SUBJECT:	VARIOUS TRAFFIC REGULATION ORDERS - AMENDMENT ORDER NO. 17 2025
MEETING:	INDIVIDUAL CABINET MEMBER DECISION – COUNCILLOR CATRIN MABY
DATE:	20/08/2025
DIVISION/WARDS AFFECTED:	WYESHAM, LLANTILLIO CROSSENNY, DRYBRIDGE, OVERMONNOW, MITCHELL TROY AND TRELLECH UNITED, RAGLAN, SHIRENEWTON, GOBION FAWR, BULWARK AND THORNWELL, ST ARVANS, DEVAUDEN, PORTSKEWETT, LLANGYBI FAWR.

- 1.1 This report seeks Cabinet Member approval to proceed with the making and implementation of the Monmouthshire County Council Traffic Regulation, Speed Limits and Parking Regulations Consolidation Order 2019 (Amendment Order No. 17) 2025.

Appendix 1: Schedule of Consultation Responses

2220 B4233/B4347 Junction, Rockfield Proposed 20mph Speed Limit

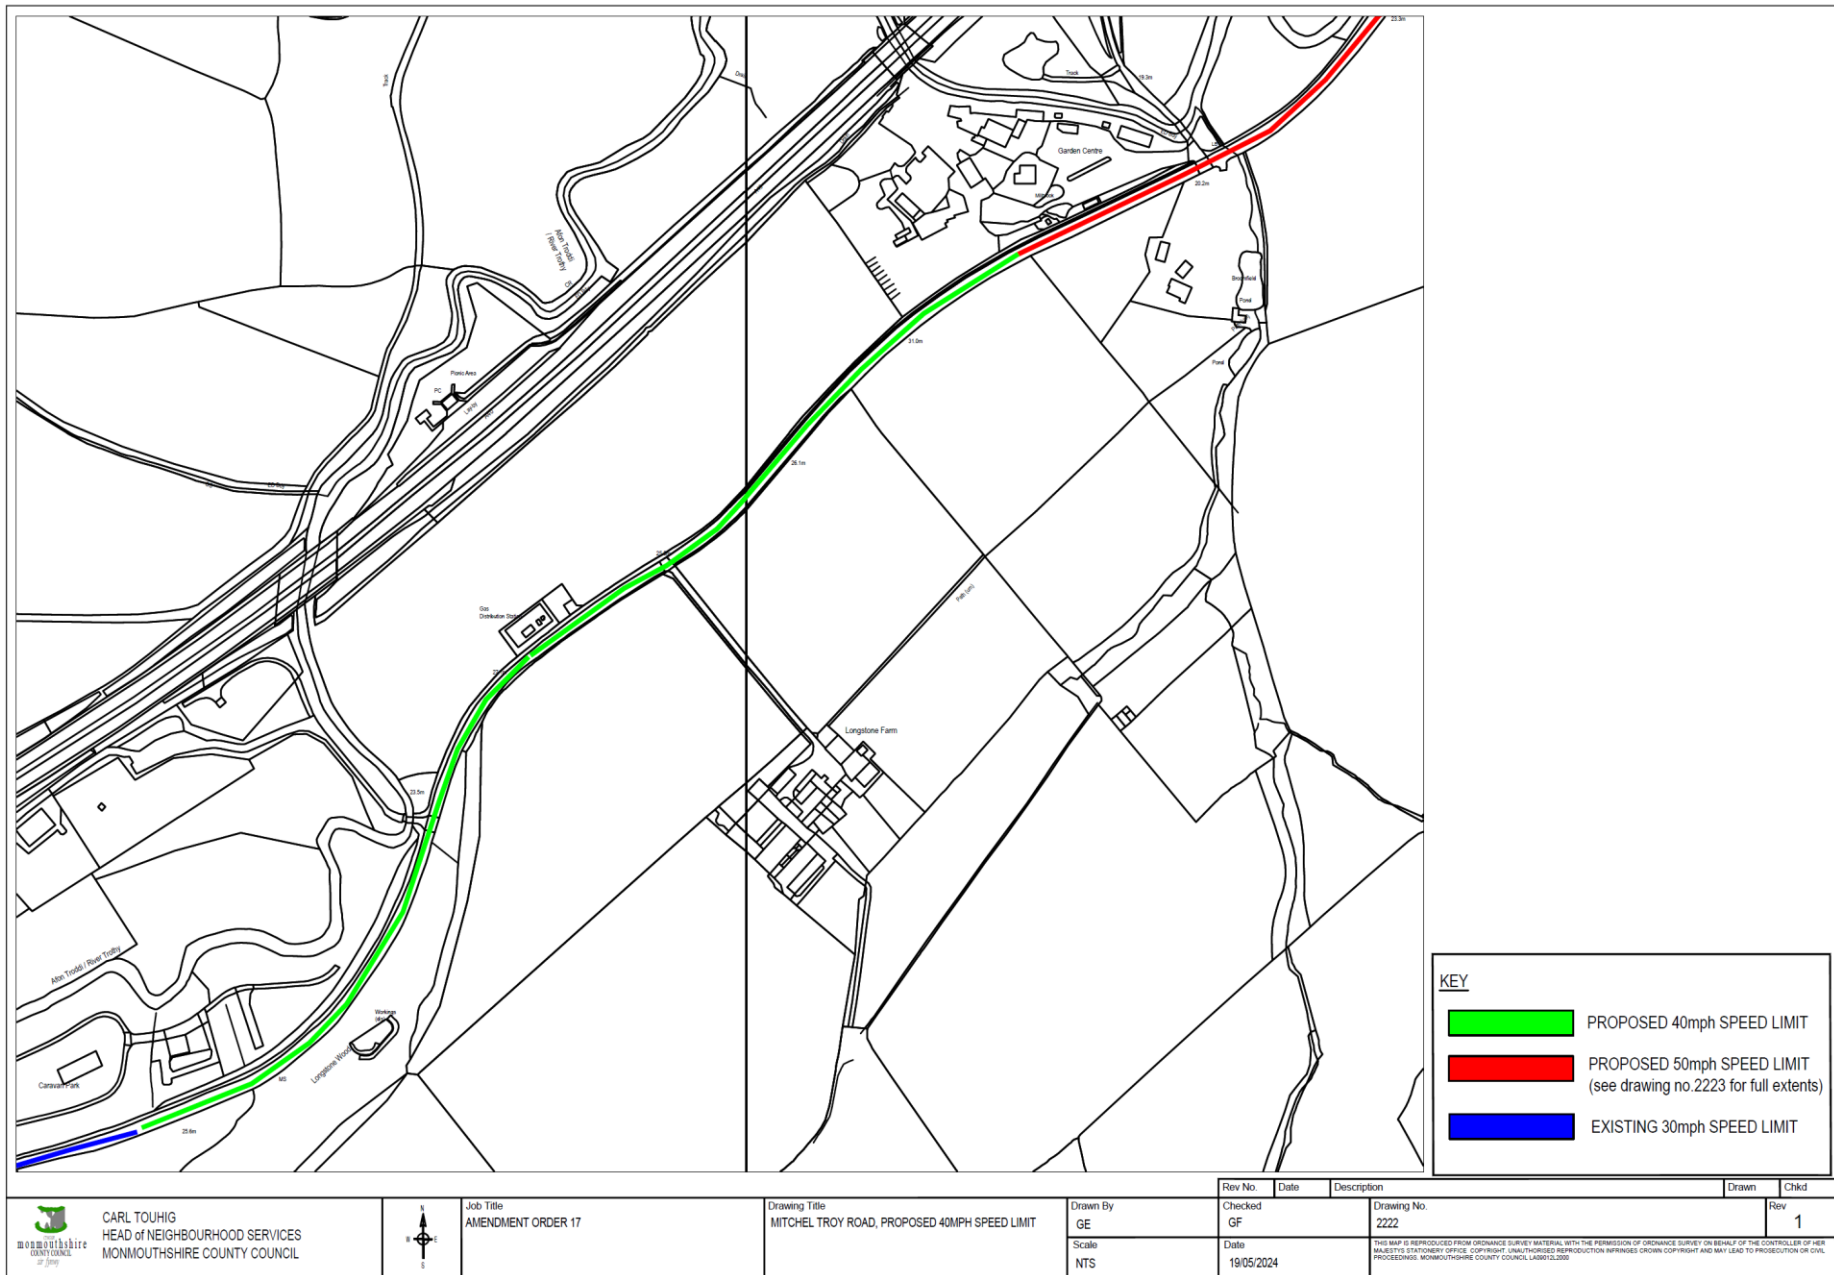
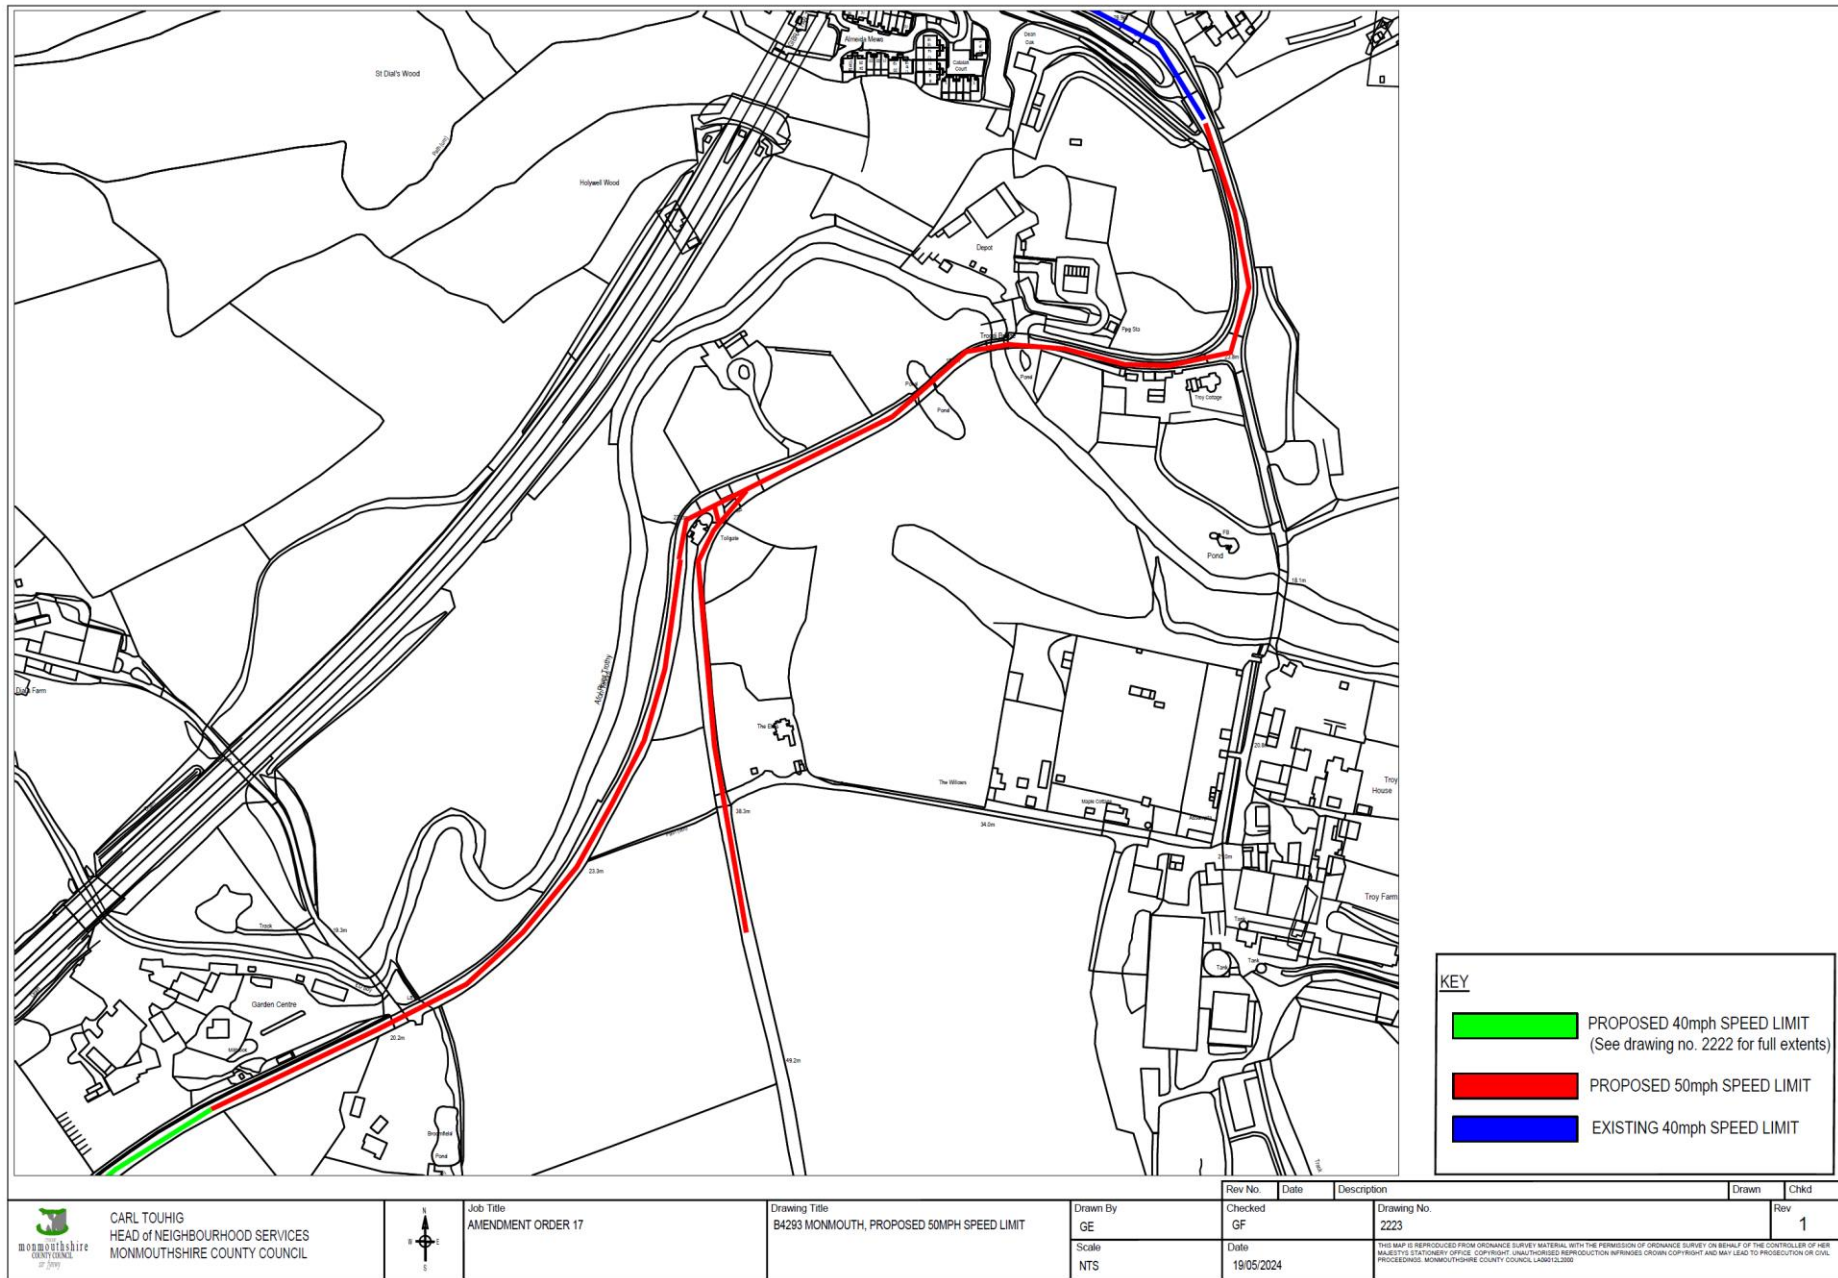
636	No	2220 B4233/B4347 Junction, Rockfield - Proposed 20mph Speed Limit (AO17)	The map is wrong. The speed limit is 30mph right up to the turn towards Newcastle and not approximately 150metres away. Is there any evidence to support this being a dangerous junction? I live practically next to it and unaware of issues surrounding speed there. The road layout means it would be reckless to attempt the blind, double bend with a large dip at even approaching 30mph with most vehicles moving closer to 20mph anyway. Changing the limit won't stop reckless driving.	Ref 636 The proposal is based on an engineering review which determined the area meets the criteria for a 20mph limit under Welsh Government guidance due to its residential character and high levels of pedestrian activity, including vulnerable road users. Formalising the speed limit to 20mph is necessary to create a legally enforceable and safer environment for all road users, reflecting the complex junction geometry and density of access points. Additionally the drawing 2220 is correct. Whilst the current extents of the 30mph may be "Right up to the turn to towards Newcastle" and extend along the B4233 through rockfield, the drawing details the extents of the 20mph speed limit that is proposed within this order. Therefore should the order be approved and implemented, the extents of the speed limits on site will be amended to reflect what is detailed in drawing 2220.

654	Yes	2220 B4233/B4347 Junction, Rockfield - Proposed 20mph Speed Limit (AO17)	I applaud the proposal for reduced speed limits at this location and would go further in proposing further reductions in speed on other sections of the B4233. As a regular car and cyclist user on this route I often witness occasions of totally inappropriate use of speed at this section of road with drivers oblivious to hazards on country roads such as HGV's, large agricultural movement along with pedestrian and cycling traffic.	Ref 654 Your support for this proposal is noted.
655	Yes	2221 B4233, Monmouth to Rockfield - Proposed 40mph Speed Limit (AO17)	I applaud the proposal for reduced speed limits at this location and would go further in proposing further reductions in speed on other sections of the B4233. As a regular car and cyclist user on this route I often witness occasions of a total inappropriate use of speed at this section of road with drivers oblivious to hazards on country roads such as HGV's, large agricultural movement along with pedestrian and cycling traffic. I would go further to say, consideration should be given to extending this 40mph proposal right up towards Rockfield, where the current 30mph exists. This section of road has some very tight bends with restricted viewing and poses particular issues when slow moving hazards, such as cyclists and agricultural machinery are ahead on the blind bends. I have often thought the National Speed limit here needs reviewing.	Ref 655 Your support for this proposal is noted.

658	Yes	2220 B4233/B4347 Junction, Rockfield - Proposed 20mph Speed Limit (AO17)	I have lived above this junction for 23 years and use it throughout the week. It is dangerous to pedestrians and cars as described, cyclists love this stretch of road too, stopping at the triangle. But it also endangers animals, having known of several cats in particular dying there. Horses and horse riders are also affected. The pavement that lines the Rockfield to Monmouth Road stops before the junction, leaving all traffic very vulnerable with no room to anticipate or get out of the way. Walking to the post box at the triangle for instance becomes a game of wits. Road safety warning are also non-existent or damaged at this junction. Aesthetically the present illogically positioned 20 speed limit sign spoils the view of the triangle, with its cross and traditional phone box and mock Tudor houses which people used to photograph! Extending this area would mean relocating the sign to a better location. Rockfield also boasts almshouses designed by Webb, Queen Victoria's favourite architect, who also designed the façade of Buckingham Palace. Other buildings of his are to be admired in the area, including the library wing of the Hendre Estate. We need to promote the appreciation of this inheritance.	Ref 658 Your support for this proposal is noted.

2221 B4233, Monmouth to Rockfield Proposed 40mph Speed Limit

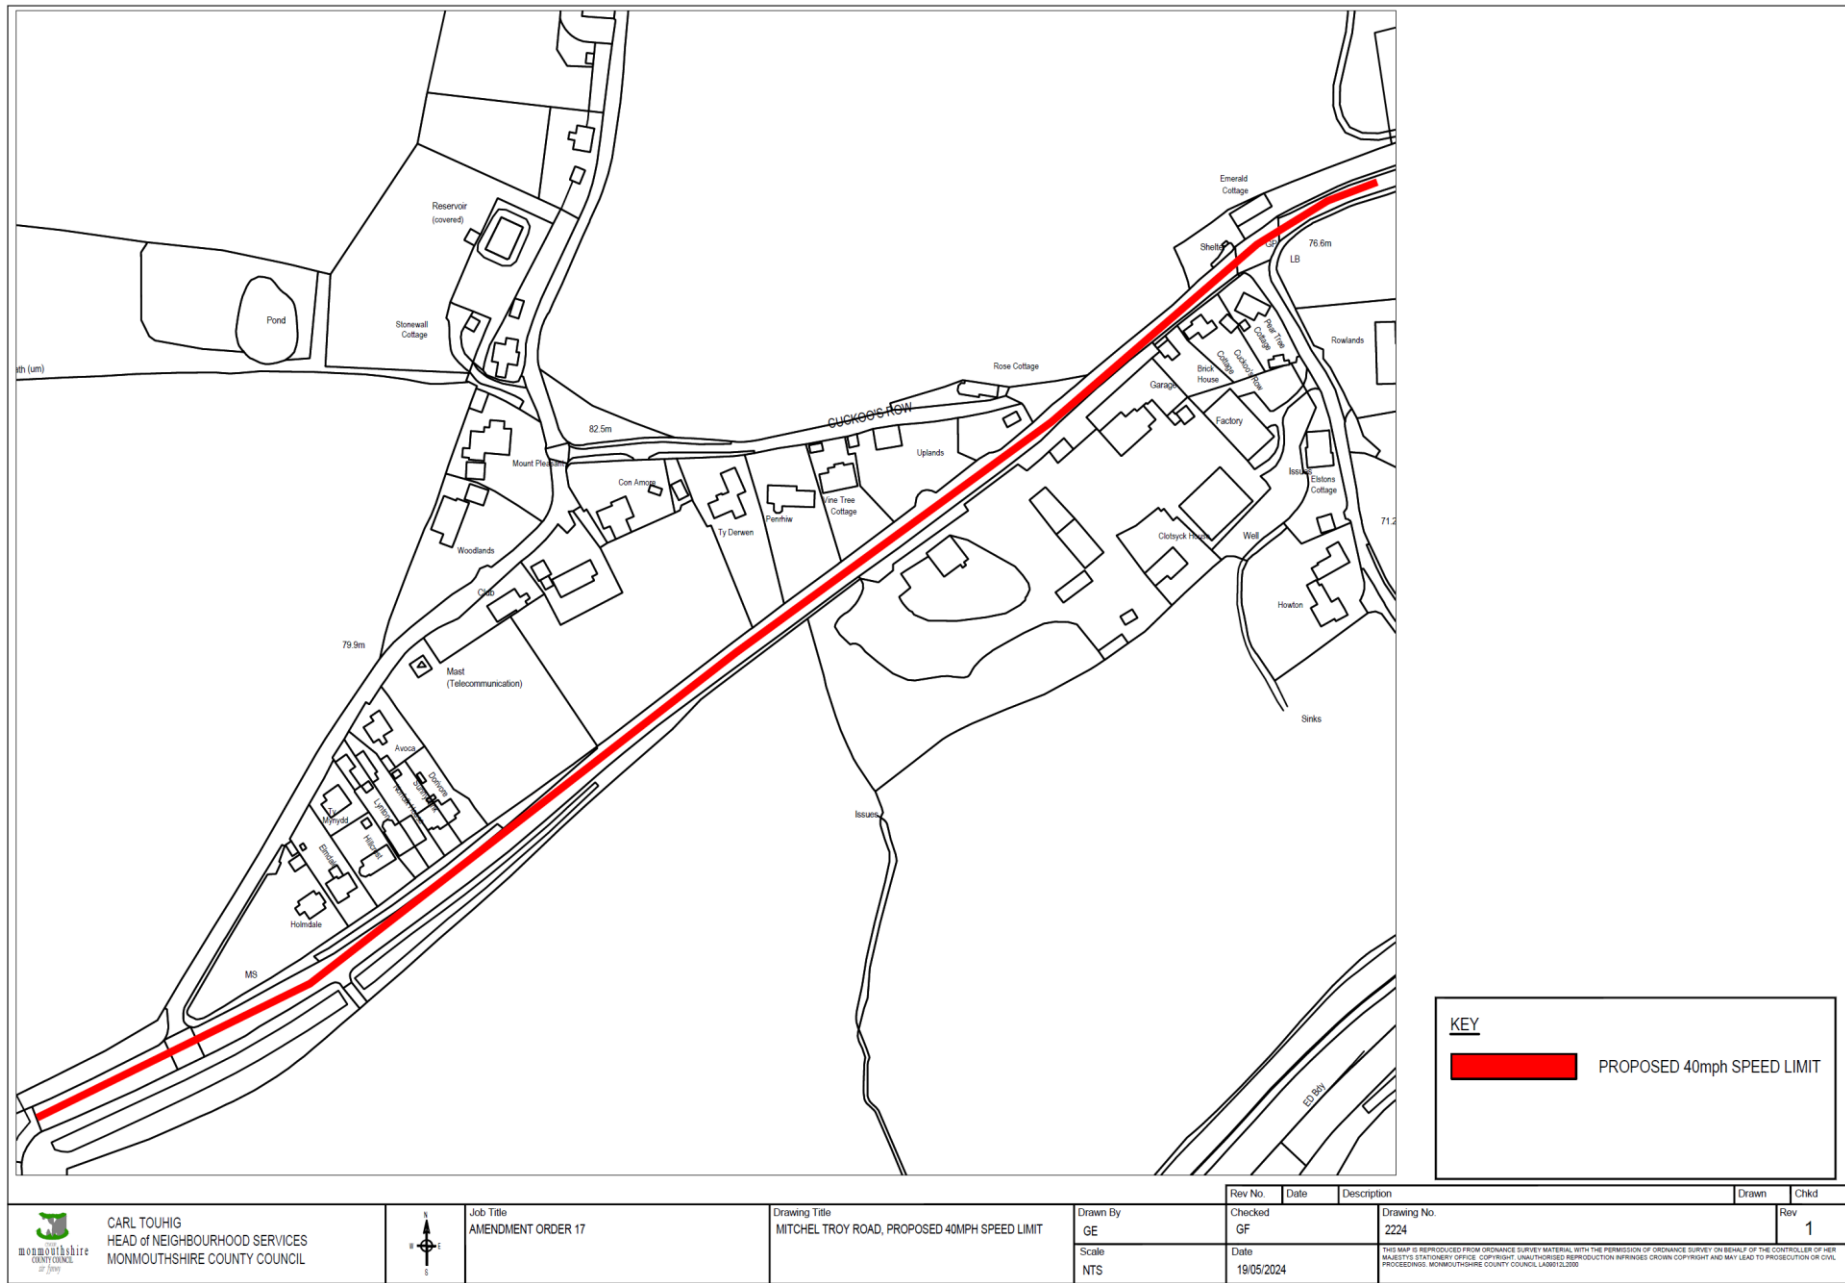
Ref.	Agree or Disagree	Order/ Location	Comments	Officers Response
635	No	2221 B4233, Monmouth to Rockfield - Proposed 40mph Speed Limit (AO17)	The road is currently an unrestricted road, therefore subject to a 60mph limit for cars. I am not aware of any reason to reduce the speed limit by a third as I am unaware of the road being prone to accidents / closures. I would be interested to see any evidence that supports the proposed reduction in speed limit. I use the road regularly as a driver, cyclist and pedestrian and have not seen any reason for the proposed change.	Ref 635 The proposal is based on a comprehensive engineering assessment. The 40mph limit provides a necessary and safer transitional speed environment between the existing speed limits in Monmouth and Rockfield. The road's alignment, with numerous bends and challenging geometry, does not safely support higher speeds. This graduated approach to speed management is essential for enhancing safety and creating a consistent speed hierarchy.

659	Yes	2221 B4233, Monmouth to Rockfield - Proposed 40mph Speed Limit (AO17)	I have used this road several times almost every day for 23 years, as have my children growing up in Rockfield. Many times I have saved the lives of cyclists hidden in the bends by anticipating their presence, slowing down well before the bend. Slow traffic, horse riders in particular are hidden in the bends. Tractors commonly use it with heavy or extra wide loads, giving no warning to drivers who discover them at the last moment. Driving at 40 max is by far the best option. In addition this road floods in heavy rain. Combined with ice, it becomes dangerous with lethal patches hidden until the last seconds. There are a few roads stemming from it adding to geographical risks, some hardly visible, as well as historic and important design locations set along the way, such as the iconic Rockfield Studios and Queen Victoria's favourite architect Webb's almshouses, worth putting on the tourism map.	Ref 659 Your support for this proposal is noted.

696	No	2221 B4233, Monmouth to Rockfield - Proposed 40mph Speed Limit (AO17)	Road is a main B road, only a couple of houses, nature of road means speeding not an issue. Enforced slower speeds will lead to more accidents as people get frustrated with individuals who do not follow speed limit and go slower and try to overtake	Ref 696 The proposal is based on a comprehensive engineering assessment of the road's physical characteristics. The 40mph limit provides a necessary and safer transitional speed environment between the 20mph zones in Monmouth and Rockfield. The road's alignment, with numerous bends and challenging geometry, does not safely support

714	No	2221 B4233, Monmouth to Rockfield - Proposed 40mph Speed Limit (AO17)	This is a new limit where none exists at present. There is no statement by the council as to why they think this is necessary which I do think should be a requirement if the public are being asked to comment. The written notice re the proposed TRO says that"further details of the proposed Order comprising a copy of the draft order, plans and a statement of reasons for proposing to make the Order" are available online at	Ref 714 The proposal is based on a comprehensive engineering assessment. The 40mph limit provides a necessary and safer transitional speed environment between the existing speed limits in Monmouth and Rockfield. The road's alignment, with numerous bends and challenging geometry, does not safely support higher speeds. The consultation has been carried out in accordance with statutory procedures.
